**North Central State Regional Council of Carpenters CUP**

**RECOMMENDATION REPORT**

CASE NUMBER: 2012-CUP-04

**NORTH ELEVATION**  
(PHASE 1 WITH FUTURE EXPANSION PROFILE DASHED)

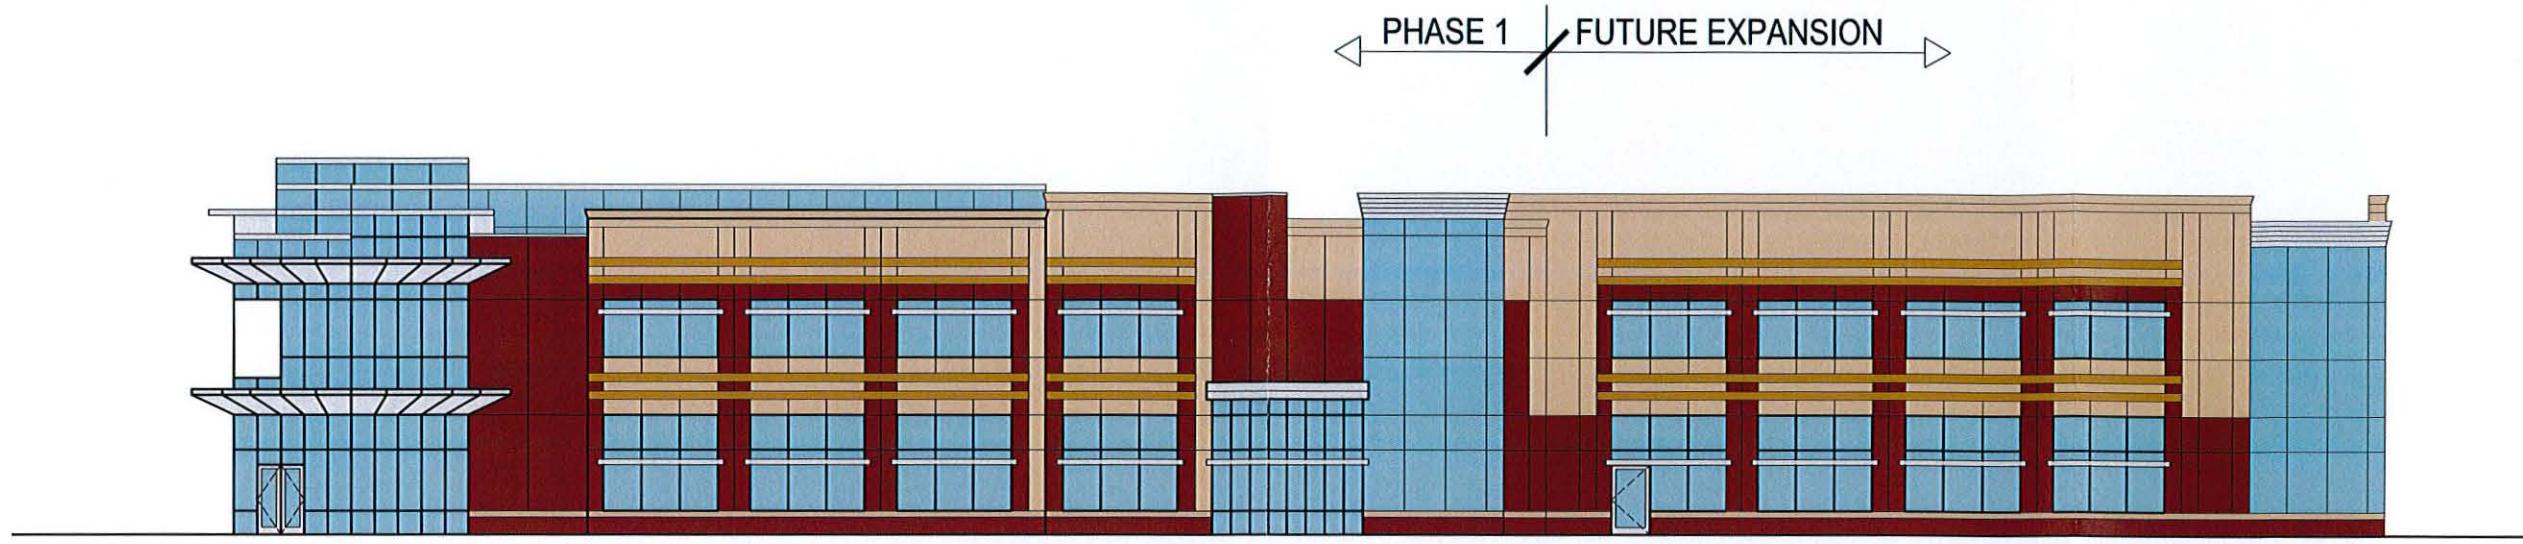
- We recommend that the doors on the north elevation should match the brick.
- Please confirm whether the parapet walls will require bracing? While we do not believe they will, being constructed of precast wall panels, we feel it is important to verify. If in fact, bracing is required, please be aware that bracing must be concealed.

- At this time, we are not confident that the parapet will provide adequate screening for the rooftop units. The design guidelines indicate these units shall not be seen in elevation – the tops clearly are visible. Without a roof plan, we do not know whether these units are at the perimeter or in the center, where they would be less visible from the ground, etc.

NCSRCC TRAINING CENTER - LA VISTA, NEBRASKA  
C.U.P. CONCEPT GRADING PLAN - OCTOBER 4, 2012  
SCALE: 1" = 30'  
06260.001

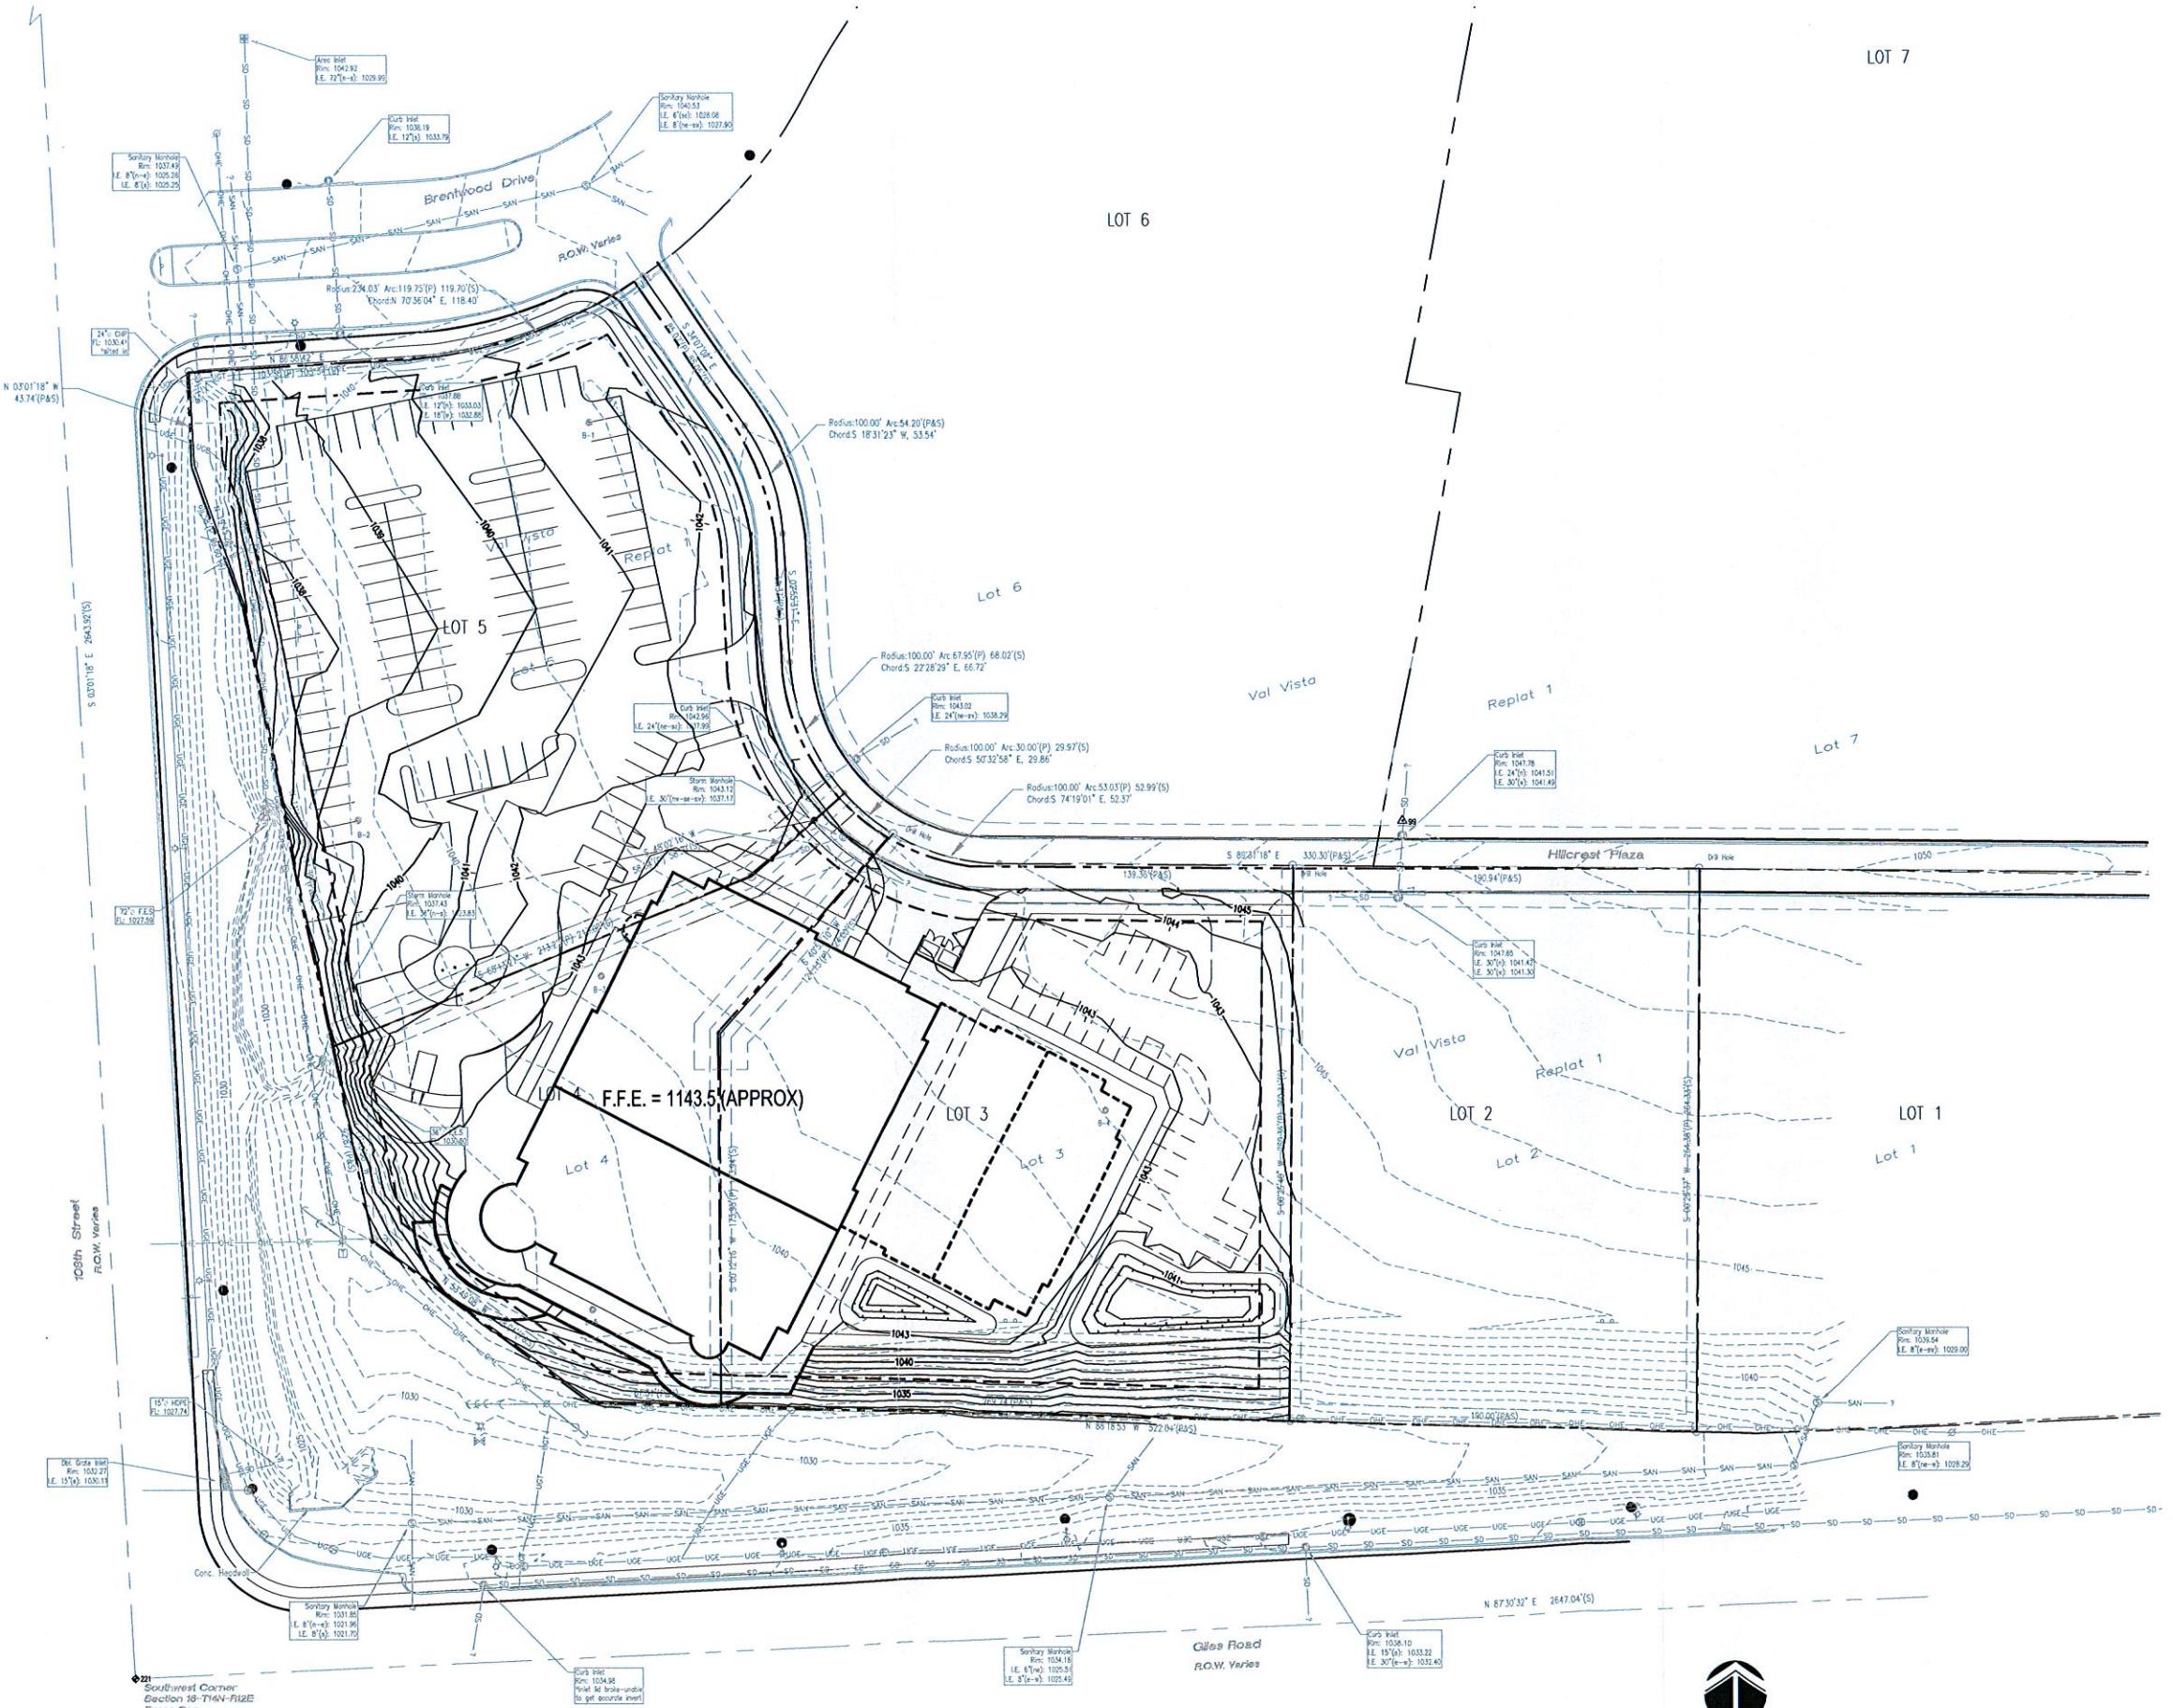
1. The proposed development will require a grading permit with erosion control compliance since the disturbed area will exceed one acre.
2. A post-construction storm water management plan will be required as part of the grading permit and building permit process
